Village of Arlington Heights Building & Life Safety Department

To: Sam Hubbard, Development Planner, Planning and Community Development
From: Deb Pierce, Plan Reviewer, Building & Life Safety Department
Subject: Arlington 425 – PUD, Preliminary Plat of Subdivision, Rezoning from R-1 to B-5, LUV for Apartment Building, Variations
PC#: 19-001 – Round 2
Date: March 3, 2019

PLAN COMMISSION PC #19-001

Planning & Community Development Dept. Review

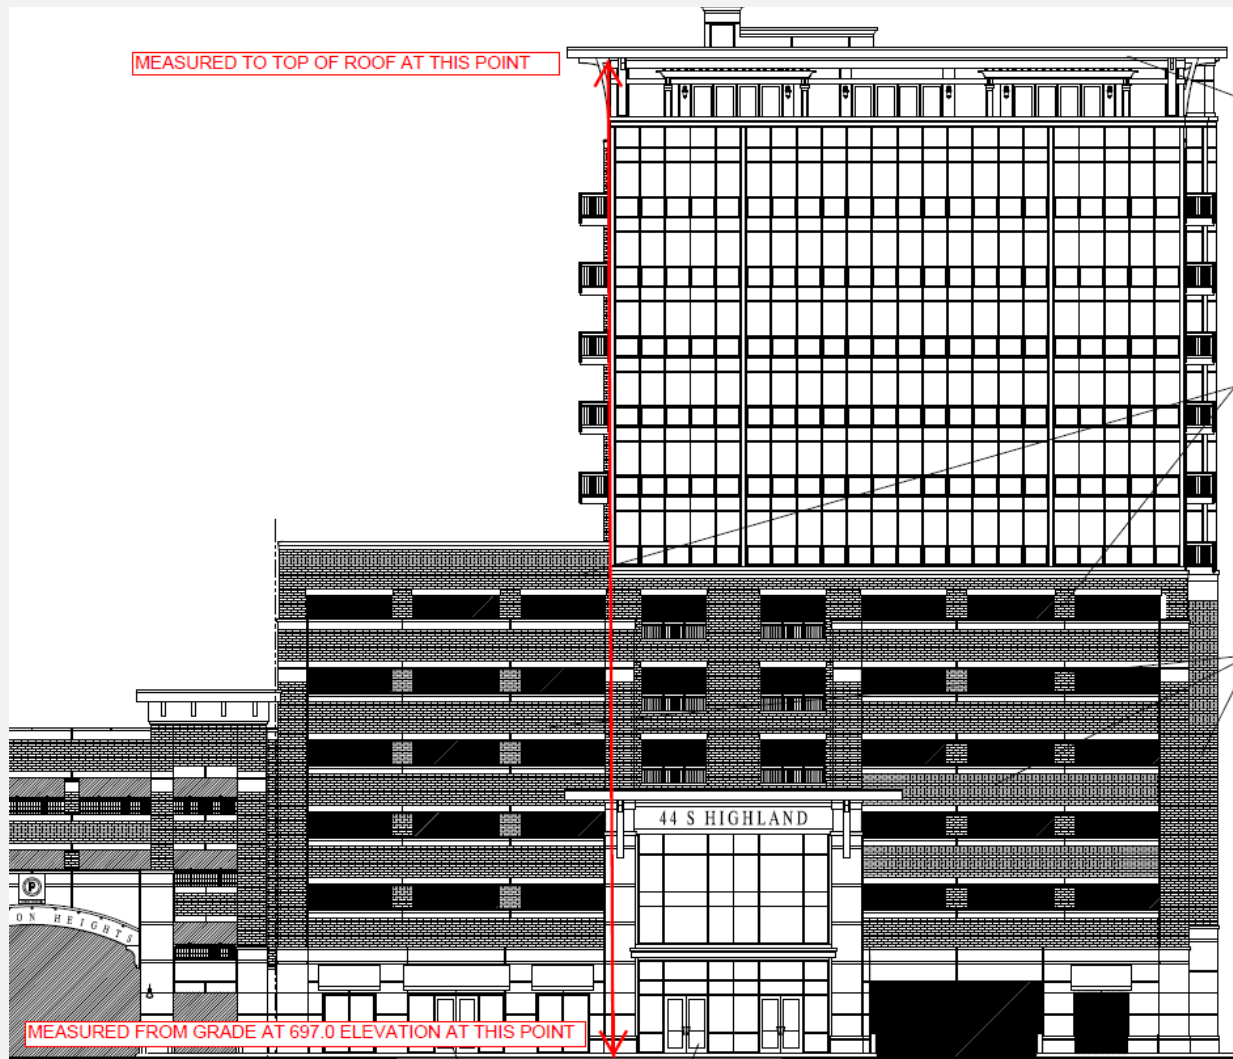
84. The response to comment #35 is noted. Staff is evaluating restrictions that would be placed on move-in/move-out days, times and locations.
85. The response to comment #42 is noted. The 140'-0" measurement is not accurate based on the code definition of building height. The code definition does not include the parapet wall. Provide an elevation and height measurement from elevation 697.00 at the north façade adjacent to the front entrance, which is what we've interpreted the established grade to be opposite the middle of the front of the building. See graphic below for further clarification:
